WEC Project Reference: 24106

Stormwater Drawing & Construction Review Memorandum for 142 Konini Road, Titirangi

Please refer to Table 1, which outlines a detailed review of the latest drawings compared to the most important relevant stormwater recommendations.

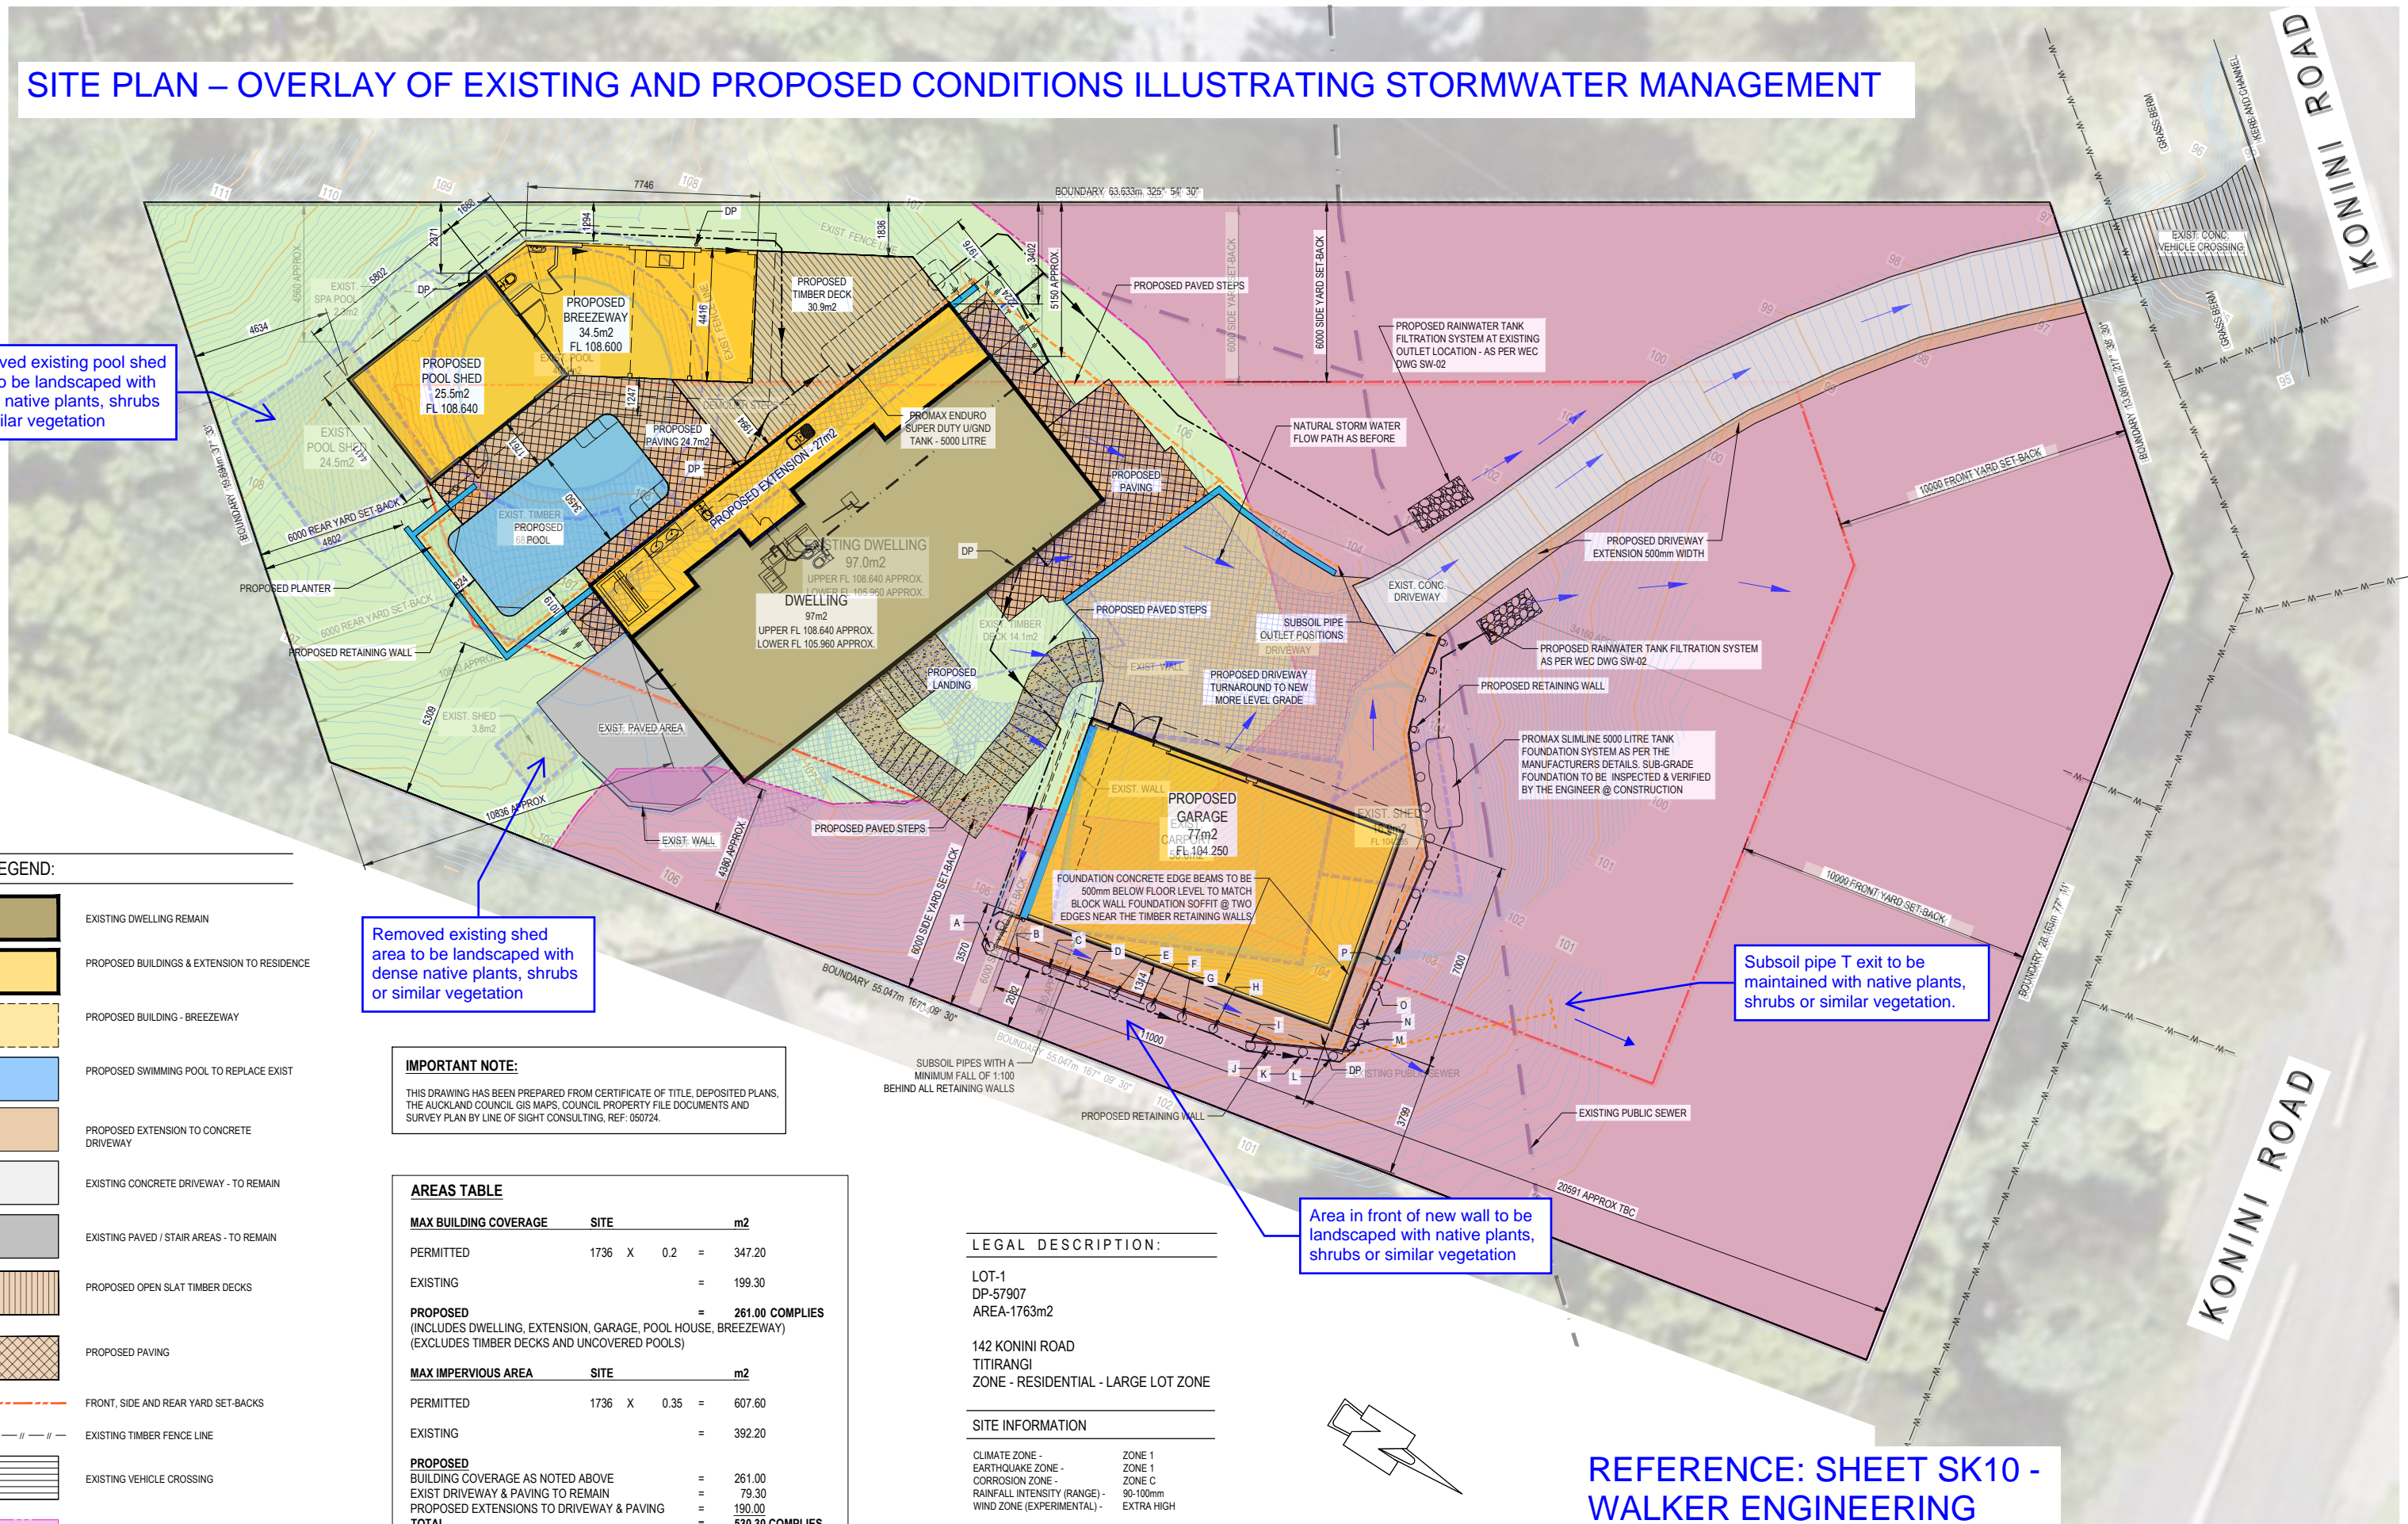
| Design Component | Stormwater Recommendation | Outcome |
|--|---|--|
| Roof & Impermeable Areas | Increased impermeable areas to be managed with stormwater detention tanks to reduce flows to below pre-development levels. | The latest drawings show impermeable areas consistent with the original stormwater assessment report. Acceptable. |
| Downpipe Positions | Position downpipes to split flows between the two detention tanks. | Drawings show new downpipes connected to the correct detention tanks: two downpipes to the lower tank and two downpipes to the higher tank. Acceptable. |
| Stormwater Tanks & Orifice Size | Provide 2 × 5000 L detention tanks (south/higher side and north/lower side of property). | 2 × 5000 L detention tanks are specified in the correct positions. Acceptable. |
| Tank Outlets | Provide a 20 mm diameter orifice 100 mm minimum above the tank base to control discharge. Provide a 100 mm diameter overflow at the tank top with a spreader pipe and rip-rap on geotextile. | Latest drawings show tanks in correct positions. Overflow outlets discharge onto rip-rap at the driveway, directing runoff to the stormwater system. Inlets and outlets are consistent with design intent. Acceptable. |
| Natural Overland Flow Path | Maintain natural overland flow path for permeable areas; vegetation away from new impermeable areas to be retained. Demolished existing building areas are to be replaced with vegetation/shrubs. | New drawings indicate flow paths consistent with pre-development conditions. Vegetation/shrubs/native plants are to be planted in front of the newly constructed retaining walls as well as in the areas where existing structures have been removed. Acceptable. |
| Subsoil Pipes Behind Walls | Provide subsoil drains behind retaining walls with outlets to the stormwater system, ensuring discharge is away from neighbouring properties. | The latest drawings show subsoil pipe positions and outlet locations that are directed away from neighbouring properties. Once permanent works are complete, exit subsoil flows will be minimal due to the minimal catchment areas. Acceptable. |

SITE PLAN – OVERLAY OF EXISTING AND PROPOSED CONDITIONS ILLUSTRATING STORMWATER MANAGEMENT

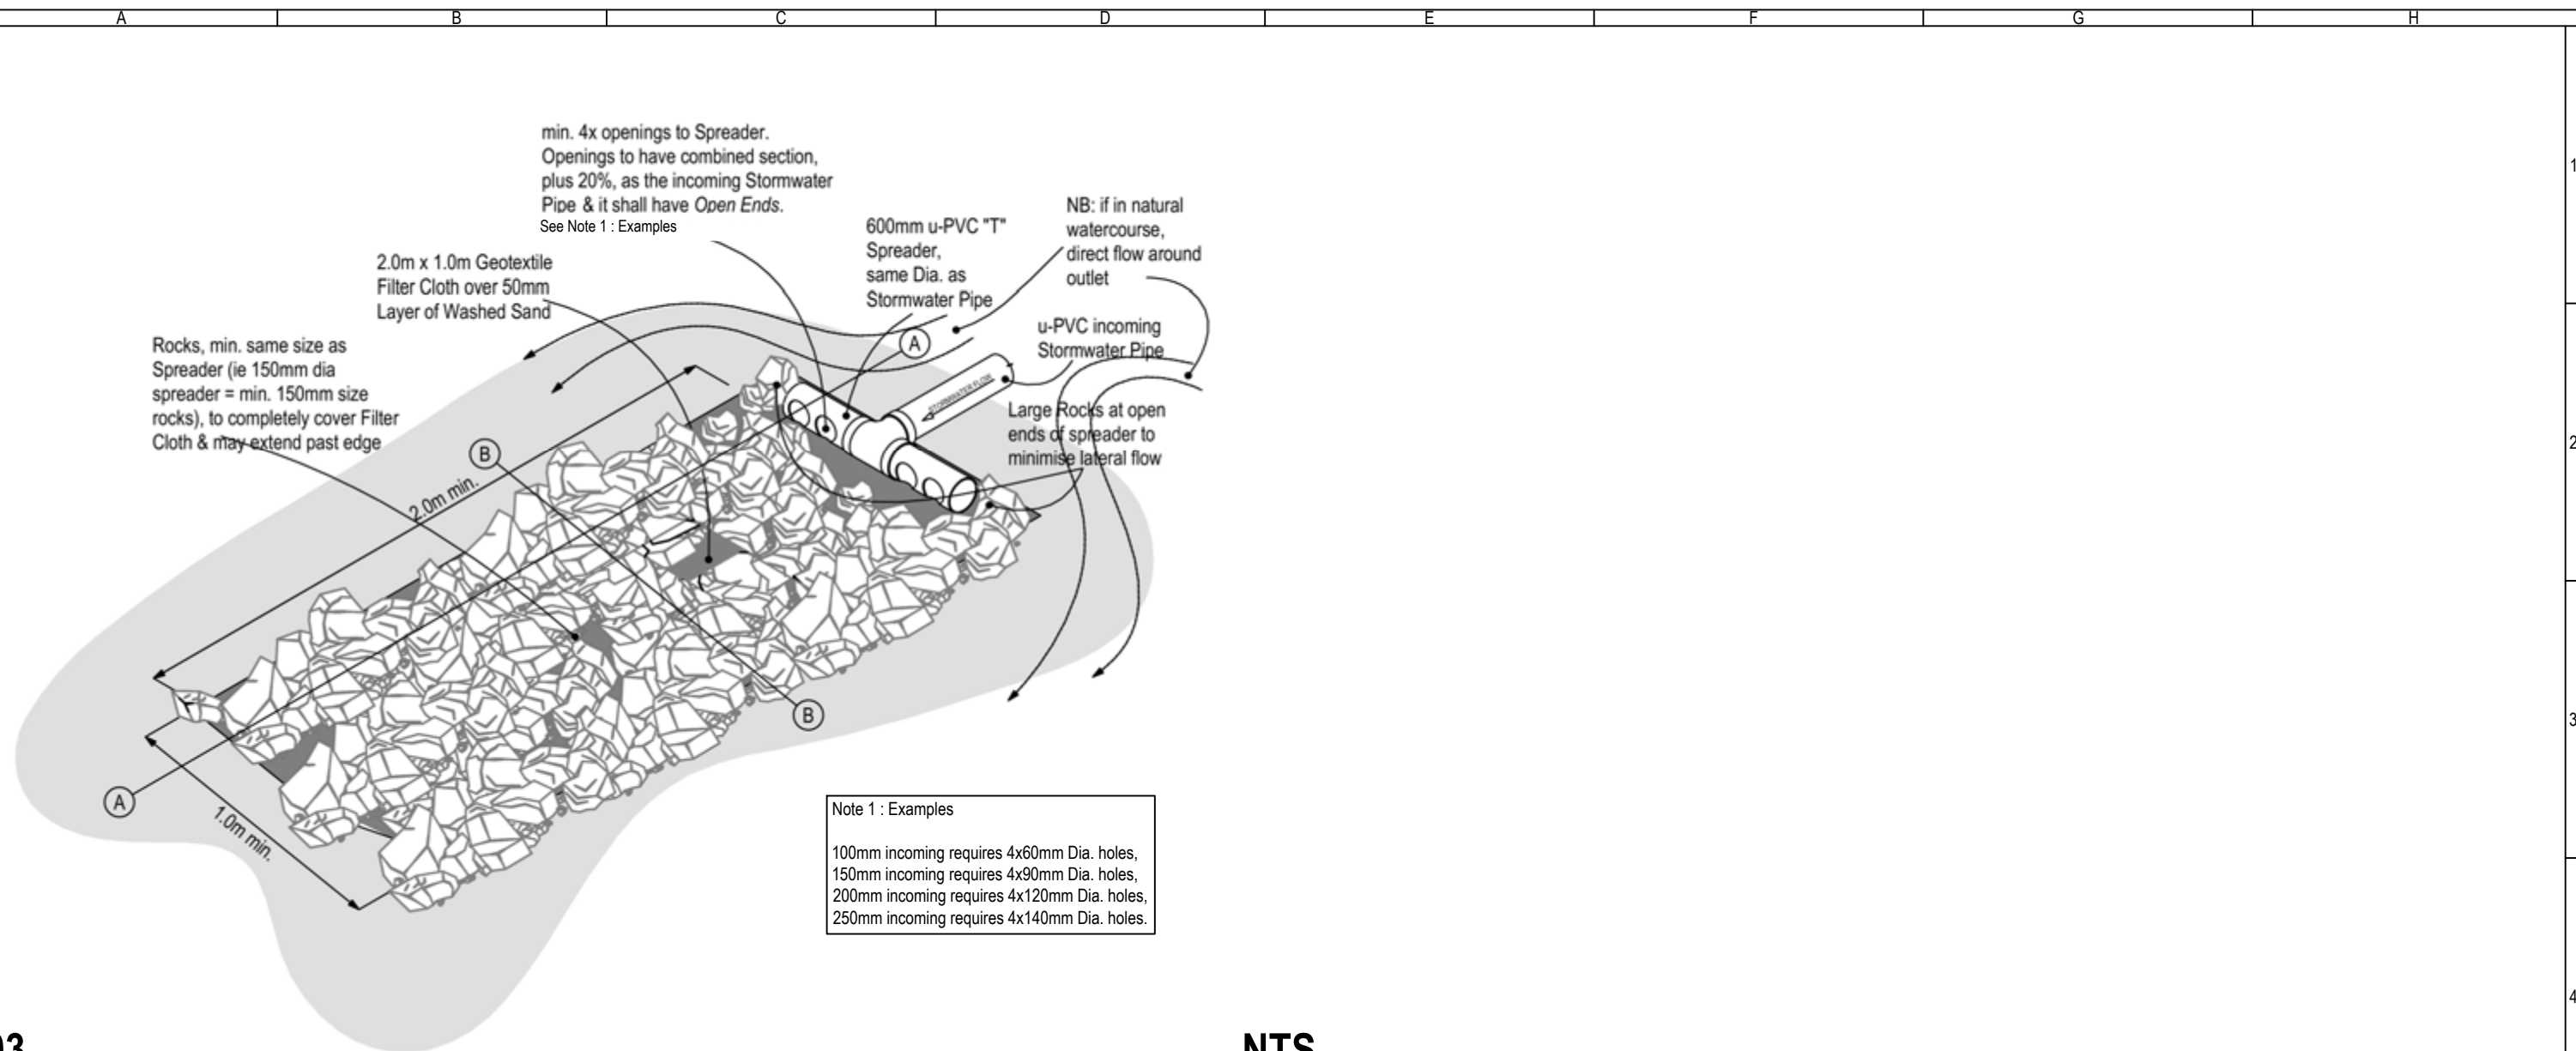
- **Overlay of Existing and Proposed Plans:** The existing site plan has been overlaid with the proposed development layout on Sheet SK10 (Appendix A). This illustrates how the stormwater management system integrates with the proposed changes, highlighting the extent of impervious surfaces, retaining structures, and new drainage outlets. Such overlays are critical for comparing pre and post-development hydrological conditions and for verifying compliance with the design intent.

Removed existing pool shed area to be landscaped with dense native plants, shrubs or similar vegetation

Removed existing shed area to be landscaped with dense native plants, shrubs or similar vegetation

Subsoil pipe T exit to be maintained with native plants, shrubs or similar vegetation.

Area in front of new wall to be landscaped with native plants, shrubs or similar vegetation

ESC EROSION & SEDIMENT CONTROL FOR EXISTING SITE: PLAN
Scale 1:400

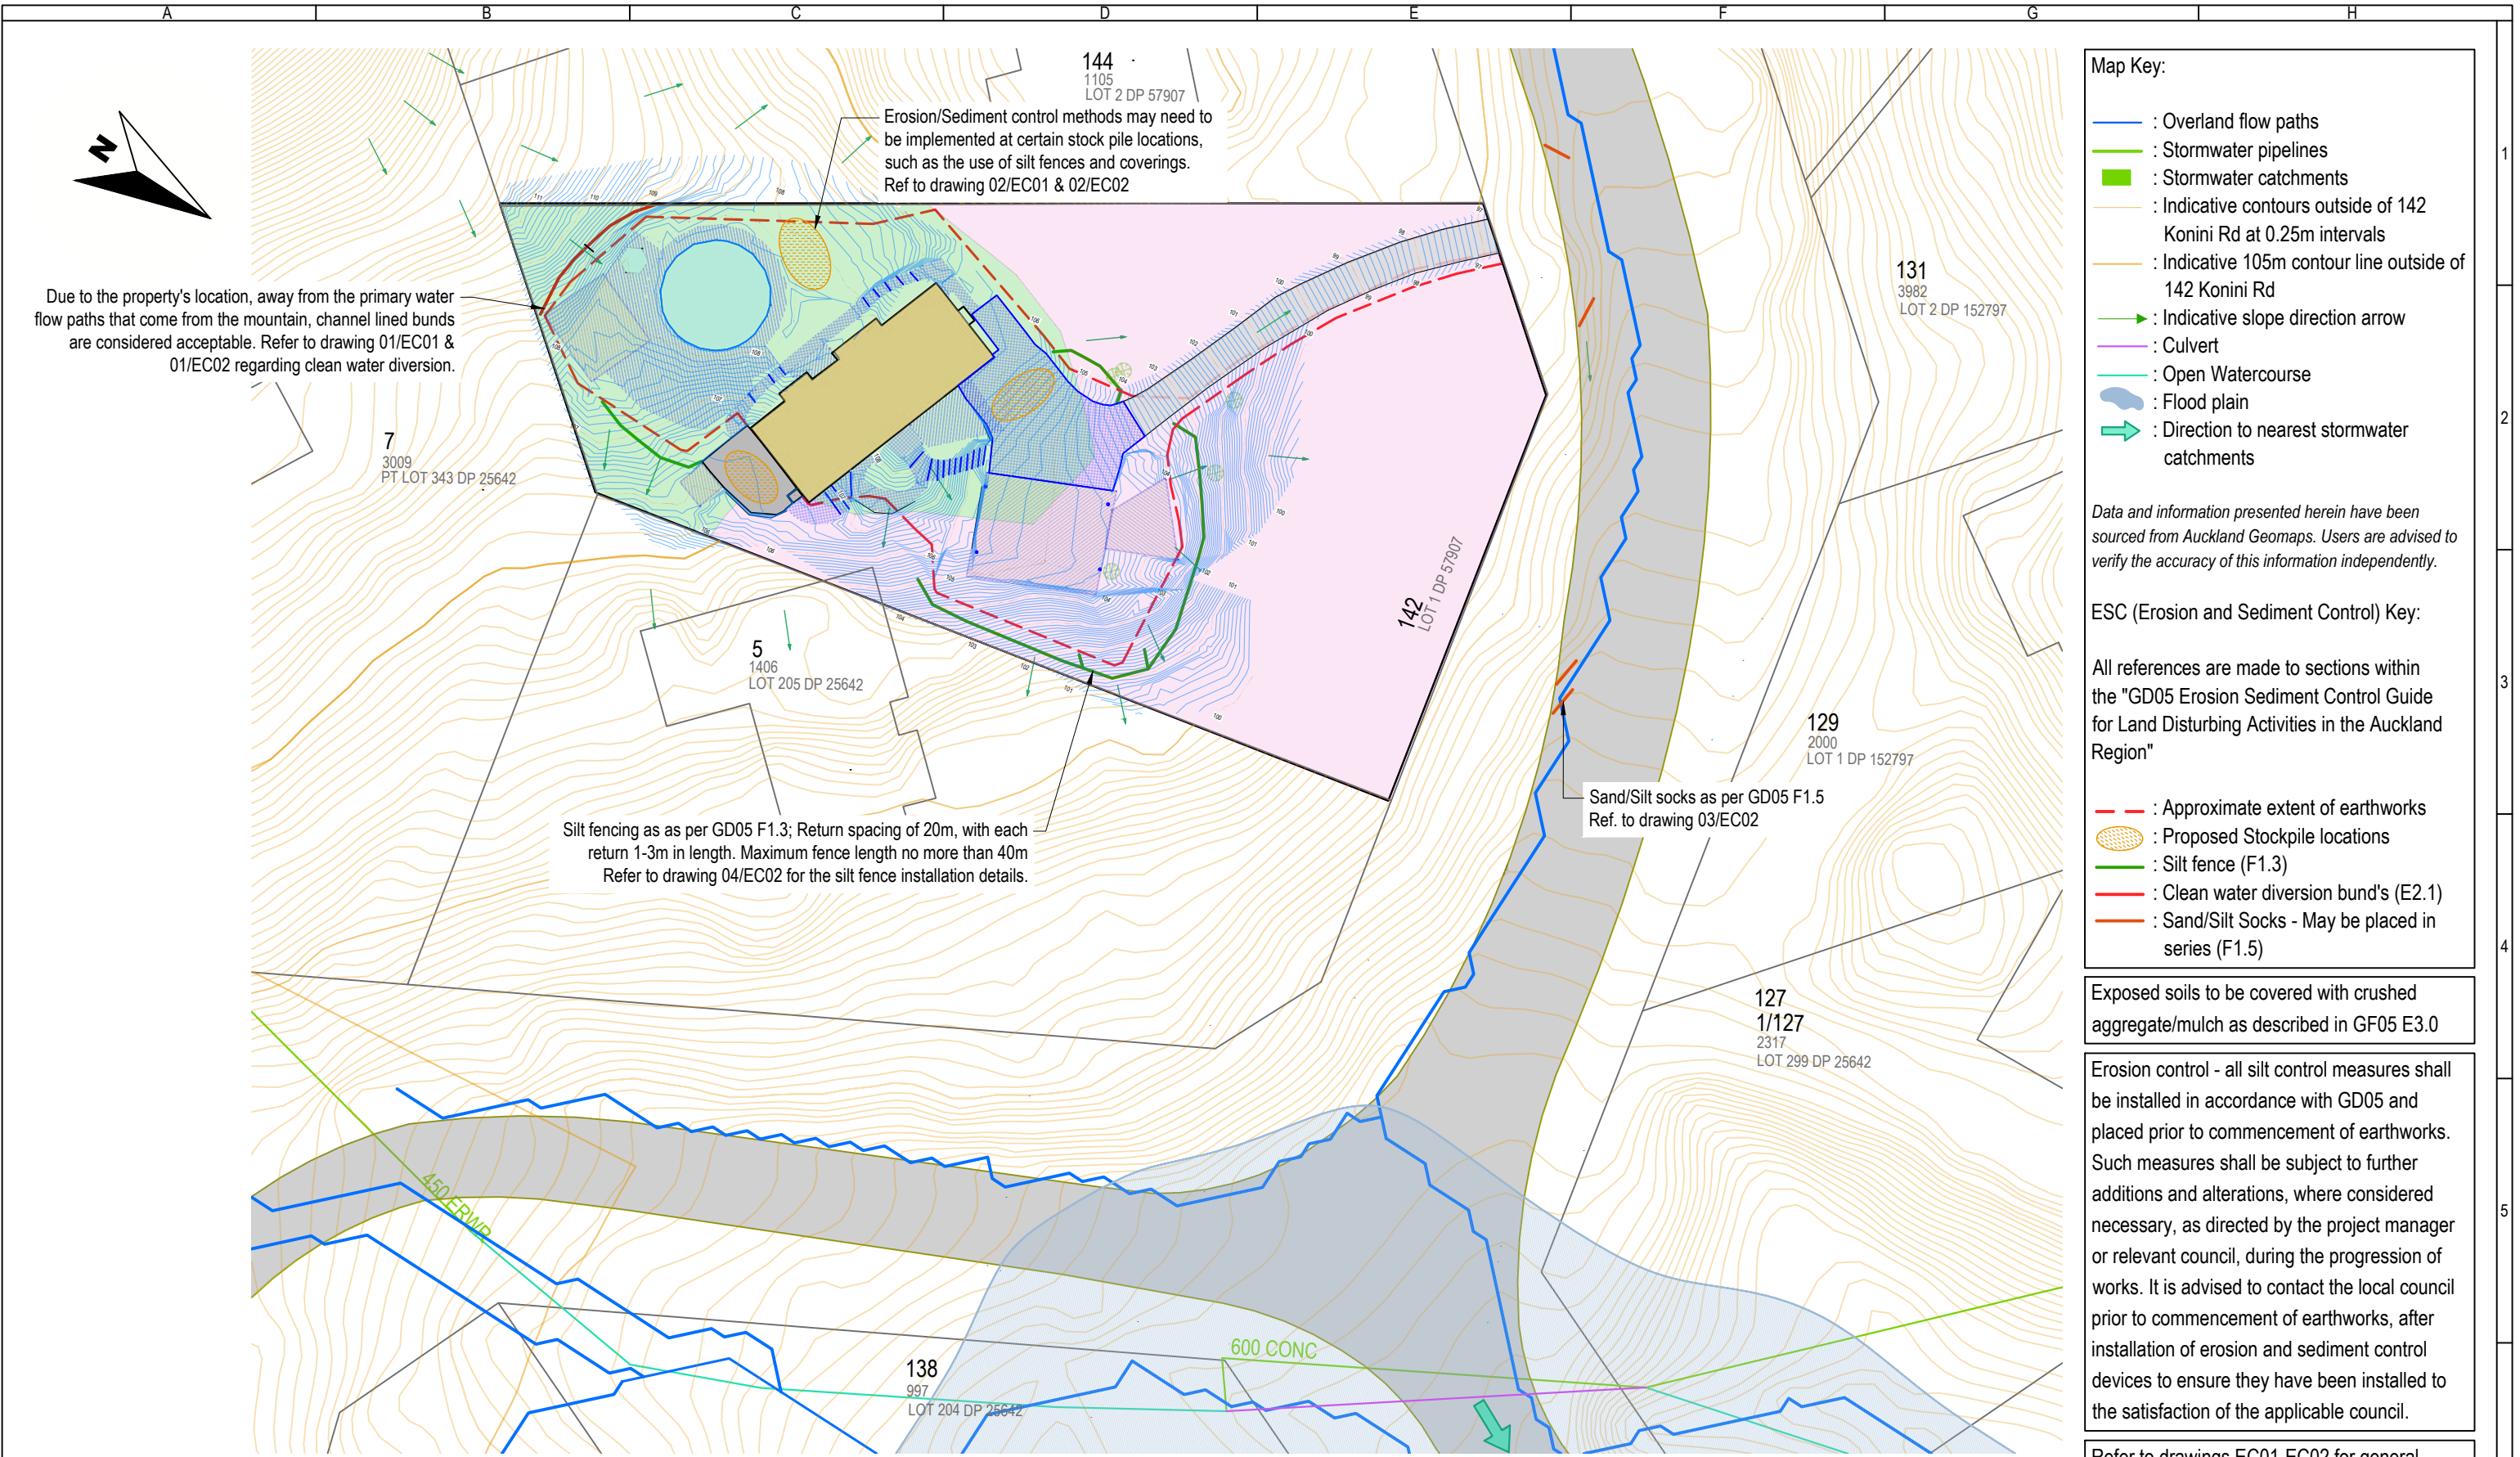
- **Erosion and Sediment Control Measures:** Not all temporary erosion and sediment control measures specified on the drawings have been implemented. In particular, a temporary bund is required at the southern boundary (Sheet ESC) to intercept and redirect overland flow away from the neighbouring property at 5 Konini Road. The absence of this measure presents a risk of uncontrolled runoff during storm events, potentially resulting in localised runoff, erosion, and neighbour complaints.

1. Install temporary erosion and sediment control measures, including the bund on the southern boundary as shown on Sheet ESC. Provide photographic evidence to the Engineer once complete.
2. Plant dense vegetation in areas where buildings have been removed and no future works are proposed, and also adjacent to the retaining walls. Provide photographic evidence to the Engineer once complete. The photographs will be attached in Appendix D of the report to illustrate that the measures are in place.
